UNITED STATES PATENT AND TRADEMARK OFFICE

APPLICATION NO.	FILING DATE	FIRST NAMED INVENTOR	ATTORNEY DOCKET NO.	CONFIRMATION NO.
10/759,534	01/20/2004	Adolf Weigl	1690.1010	7114

Office Action Summary	Application No.		Applicant(s)	
	10/759,534		WEIGL, ADOLF	
	Examiner		Art Unit	
	Gene L. Bankhead		3744

DETAILED ACTION

Figure A (Higo)

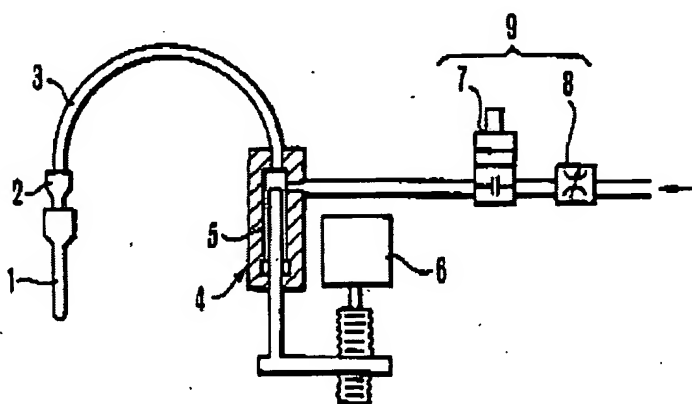
Regarding claims 3 and 4 the injection device, Figure A below, comprises:

A reservoir 5 capable of storing an antibacterial substance, an injection pump 4 activated electrically by the control device (column 4 lines 6-23) and at least one nozzle head 2 connected to an outlet of the injection pump via a pipeline 3. The injection pump

has a compressible volume filled with active substance and an actuation mechanism capable of the abrupt compression of the volume (column 1 lines 50- 68 and column 4 lines 7-24).

With regards to claim 8, the nozzle holder 2 joins the nozzle head 1 and the pipeline, (see Figure A).

Figure A (Higo)

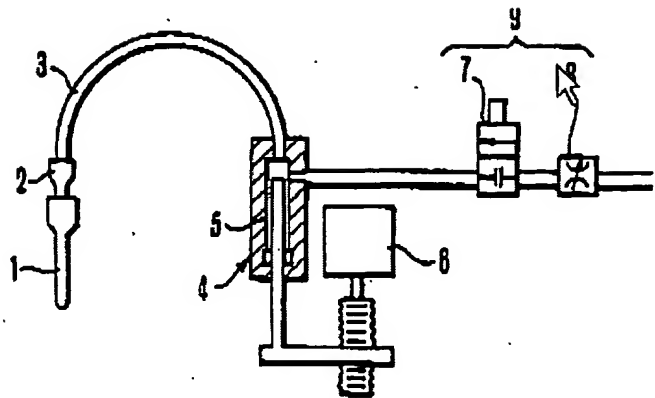
Claims 5-7 are rejected under 35 U.S.C. 103(a) as being unpatentable over Higo. Higo discloses all limitations of claim 2 as previously stated. Higo does not expressly disclose however non-return valve arranged between the outlet of the injection pump and the nozzle head. Instead, Higo discloses the non-return valve 8 and the nozzle head situated on opposite sides of the injection pump, see Figure A below.

At the time the invention was made, it would have been an obvious matter of design choice to a person of ordinary skill in the art to place a non-return valve between the outlet of the injection pump and the nozzle head. Applicant has not disclosed that placing the non-return valve between the outlet of the injection pump and the nozzle head provides an added advantage, has a particular purpose, or is a solution to a stated problem. One of ordinary skill in the art would have expected the claimed invention to function equally well with the non-return valve between the injection pump and nozzle head or the injection pump between the non-return valve and the nozzle head.

Figure B (Benalikhoudja)

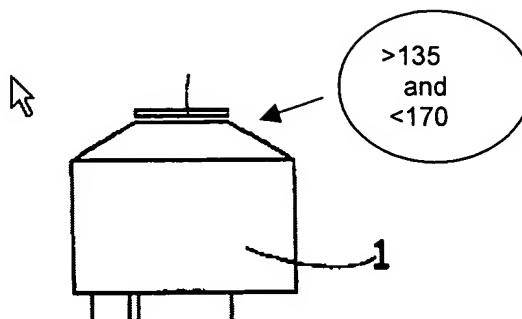
Claim 9 is rejected under 35 U.S.C. 103(a) as being unpatentable over Higo in view of Benalikhoudja (US 6405944). Claim 9 differs from Higo in calling for a nozzle head with a spray cone with an opening angle of between 135 and 170 degrees. Benalikhoudja discloses a spray cone 1; see Figure B below,

with an opening angle between 135 and 170 degrees (column 3 lines 20-28). The spray cone is a nebulization device suited to produce liquid particles having different viscosities and extremely small dimensions, and to diffuse them in order to form a spray or an aerosol (column 4 lines 4-10). Benalikhoudja teaches the discharge of large particles from nebulization devices leads to unnecessary loss of fluid and can be very costly (column 1 lines 40-45). Therefore it would have been obvious to one of ordinary skill in the art at the time of the invention to modify the nozzle head of Higo with Benalikhoudja because the nozzles geometric shape enables it to trap large particles, and thus prevent any axial exit of the spray (column 1 lines 45-51 and column 2 lines 25-67 and column 3 lines 1-32).

Figure C (Brickley)

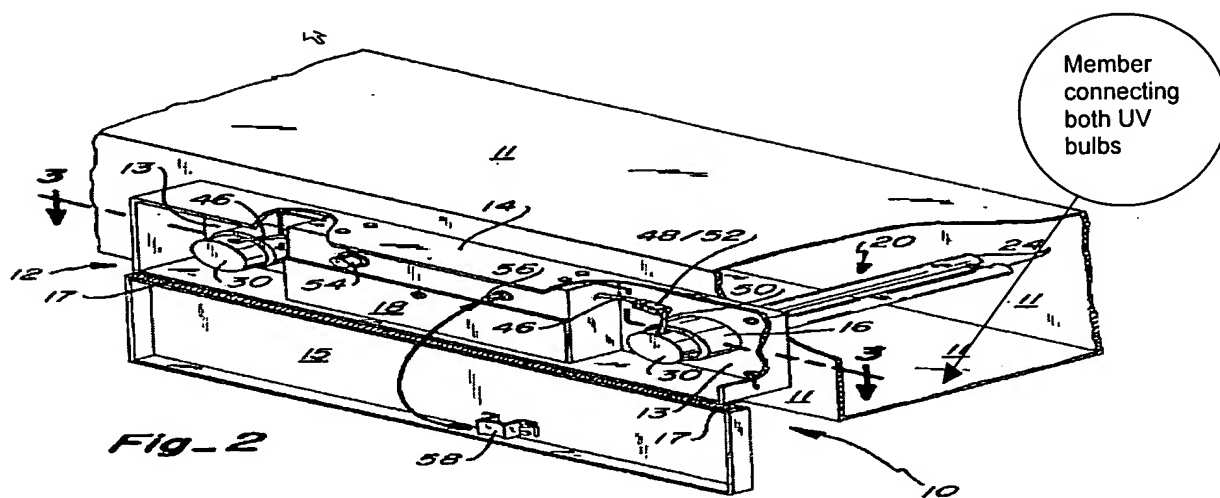
Claims 24 and 34 are rejected under 35 U.S.C. 103(a) as being unpatentable over Higo in view of Brickley (US 5902552). Claim 24 differs from Higo in calling for a

UV lamp. Brickley discloses an ultraviolet air sterilization device 10, with removable UV lamps 20. The lamps are mounted on receptacles 30 and are aligned in an air stream of an air-handling unit duct 11 (column 2 lines 1-35). It is well known in the art ultraviolet light sources are an excellent means for killing bacteria and microorganisms in air streams. Therefore it would have been obvious to one of ordinary skill in the art at the time of the invention to incorporate the removable UV lamps of Brickley into the injection device of Higo in order to clean and sterilize the air circulating through commonly used closed spaces for air conditioners, such as offices and hospitals.

Figure D (Elmore)

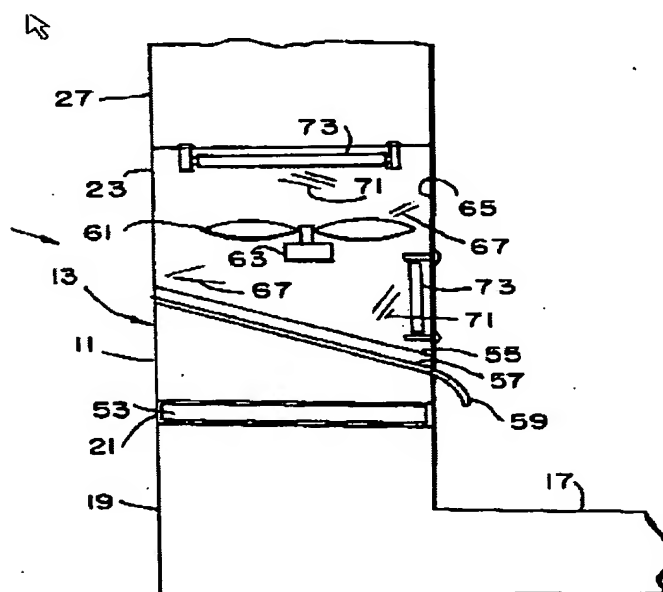
Claims 25 and 26 are rejected under 35 U.S.C. 103(a) as being unpatentable over Higo in view of Elmore (US5558158). Claim 25 differs from Higo in calling for an UV lamp with air guide elements. Elmore discloses UV lamps 73 in a duct 17. Elmore further discloses air guide elements, 67, 59, and 53, that partially inhibit smooth airflow past the UV lamps and partially prolong the dwell time of the air in the region of the lamp, see Figure D below. It is well known in the art ultraviolet radiation is an excellent means of killing bacteria and harmful biological material in airstreams. Therefore it would have been obvious to one of ordinary skill in the art to at the time of the invention to incorporate the ultraviolet lamps of Elmore into the injection device to thoroughly clean and purify air that flows through common air conditioning systems, such as those in schools and laboratories.
